Access Compliance Report

Public Rights-of-Way

Intersection ID: 18058	Main Street: COLONY_RD	Cross Street: ROSWELL_AV	Location: NW
ADA ID: 1864FA1488BB	Ramp Type: Directional1	Initial Pass/Fail: Fail	Overall Compliance: No
		Severity Score: 37.5

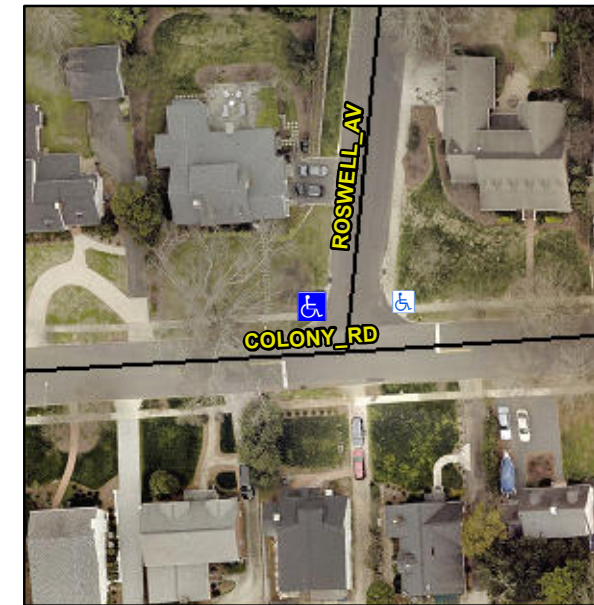
R304.2.2, R304.5.3

Compliance	Description	Data	Compliance	Description	Data
N/A	Ramp Length (in)	66.0	N/A	Grade Break?	N/A
Yes	Ramp Width (in)	48.0	N/A	Grade Break Slope (%)	0.0
No	Ramp Slope (%)	14.0	N/A	Grade Break XSlope (%)	0.0
No	Ramp XSlope (%)	5.2			
N/A	Flare Type LT	N/A	N/A	Flare Type RT	N/A
N/A	Flare Slope LT (%)	N/A	N/A	Flare Slope RT (%)	0.0
N/A	Flare Traversable LT?	N/A	N/A	Flare Traversable RT?	N/A
N/A	Landing Length (in)	0.0	N/A	DWS Provided?	N/A
N/A	Landing Width (in)	0.0	N/A	DWS Contrast?	N/A
N/A	Landing Slope (%)	0.0	N/A	DWS Length (in)	N/A
N/A	Landing X Slope (%)	0.0	N/A	DWS Full Width?	N/A
N/A	Landing Curb? (Y/N)	N/A	N/A	DWS Offset LT (in)	N/A
N/A	Shared Landing?	N/A	N/A	DWS Offset RT (in)	N/A
N/A	Gutter Ponding?	0.0	N/A	Gutter Slope (%)	N/A
N/A	Gutter Lip Ht (in)	0.0	N/A	Gutter X Slope (%)	N/A
N/A	Painted X Walk1?	No		Road Slope (%)	0.7
	X Walk 1 Direction	To NE		Road X Slope (%)	4.3
	X Walk 1 Width (in)	N/A		Clear Space?	N/A

Remove & Replace Entire Ramp.
